REFERENCE:	TSB: 23-020-23 REV. A GROUP 23 - Body	Date:	February 8, 2023	REVISION:	23-020-23
VEHICLES AFFECTED:	2018 - 2023 (JL) Jeep Wrangler 2020 - 2023 (JT) Jeep Gladiator	MARKET APPLICABILITY:			
		<input checked="" type="checkbox"/> NA		<input checked="" type="checkbox"/> MEA	
		<input checked="" type="checkbox"/> SA		<input checked="" type="checkbox"/> CH**	
		<input checked="" type="checkbox"/> **EE		<input checked="" type="checkbox"/> IAP	
CUSTOMER SYMPTOM:	Corrosion found on the door, hood and/or swing gate hinge(s).				
CAUSE:	Hinge composition

This bulletin supersedes Technical Service Bulletin (TSB) 23-020-23, date of issue February 01, 2023, which should be removed from your files. All revisions are highlighted with ****asterisks**** and include additional markets.

Fig. 1
Zinc Shim

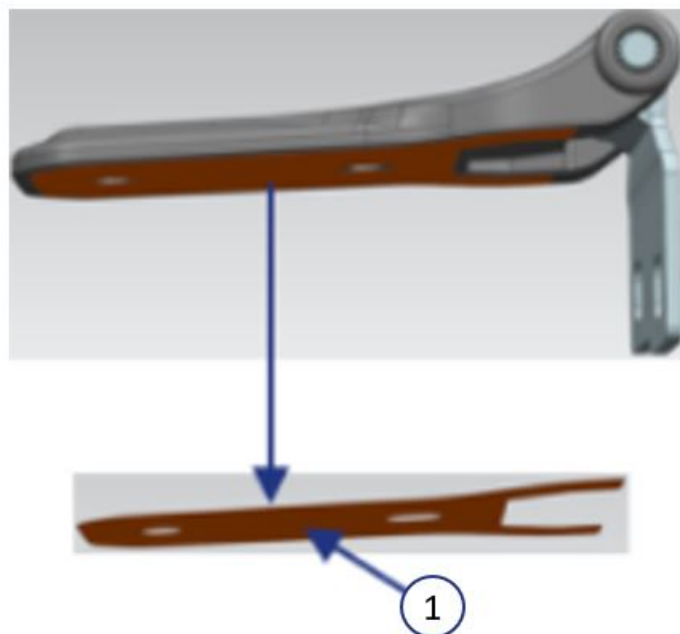
This bulletin involves inspecting and replacing any hinge exhibiting corrosion. The replacement hinge is equipped with a Zinc shim (Fig. 1) .
